**City of Portland, Maine – Building or Use Permit Application** 389 Congress Street, 04101, Tel: (207) 874-8703, FAX: 874-8716

BUILDING PERMIT REPORT

DATE: 11 OCT 2008 ADDRESS: 621 Island Ave. P.I CBL: 092-E-018  
REASON FOR PERMIT: Demo. of Porch; build new porch, roof, etc.  
BUILDING OWNER: Maybelle & Mark Crasnick  
PERMIT APPLICANT: \_\_\_\_\_ CONTRACTOR: Longelle Const.  
USE GROUP: R-3 CONSTRUCTION TYPE: 59 CONSTRUCTION COST: \$27,500 PERMIT FEES: \$750.

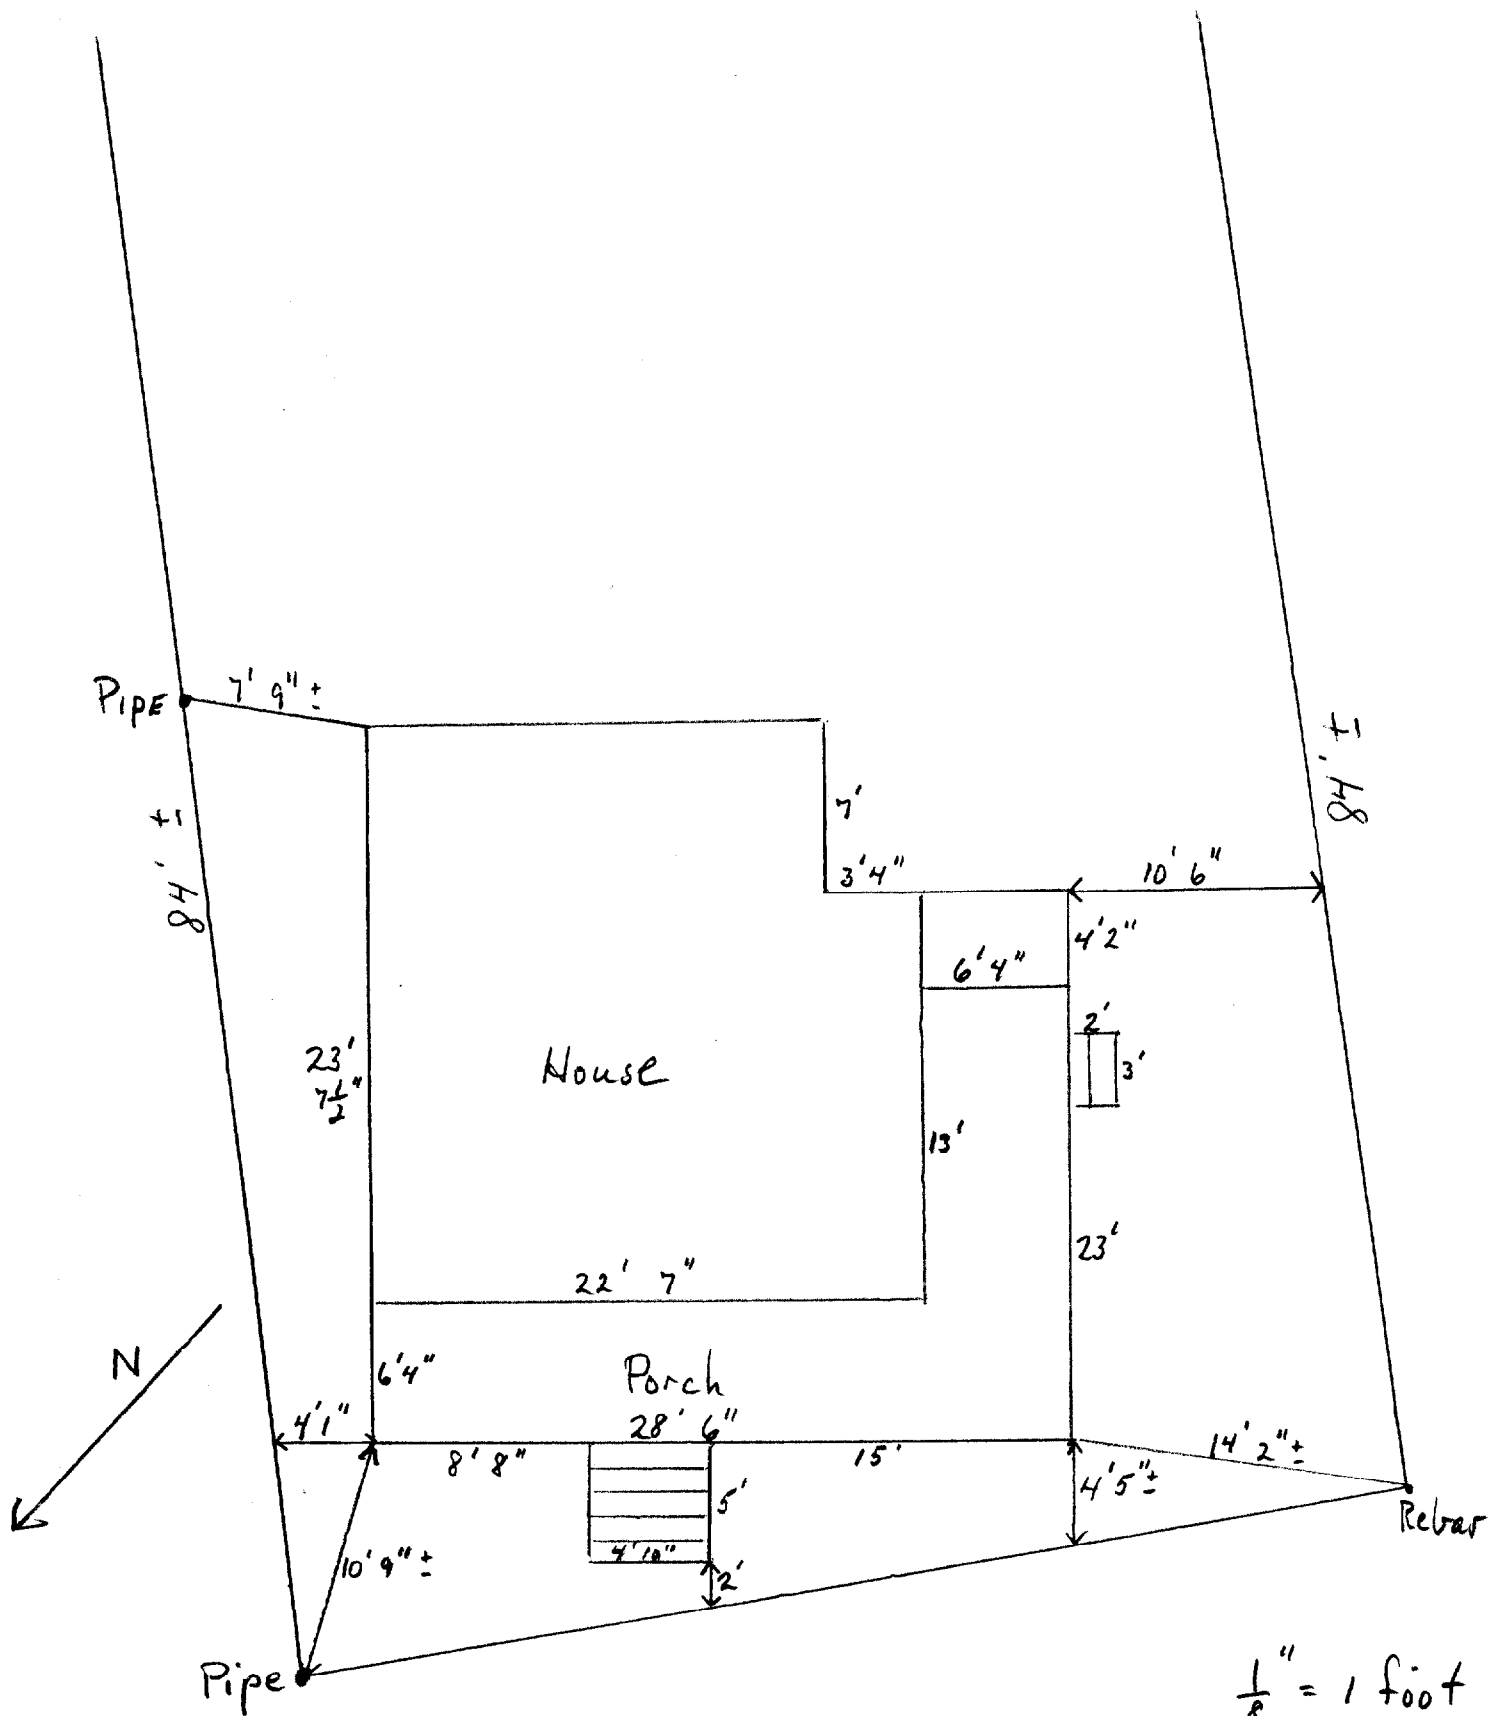
*There shall be no increase to the existing footprint. No increase has been suggested in any submitted materials. If there is any change, you must first contact this office.*

All is existing according to the  
Contractor Agreement -  
There shall be no increase in  
the existing footprint -  
see condition
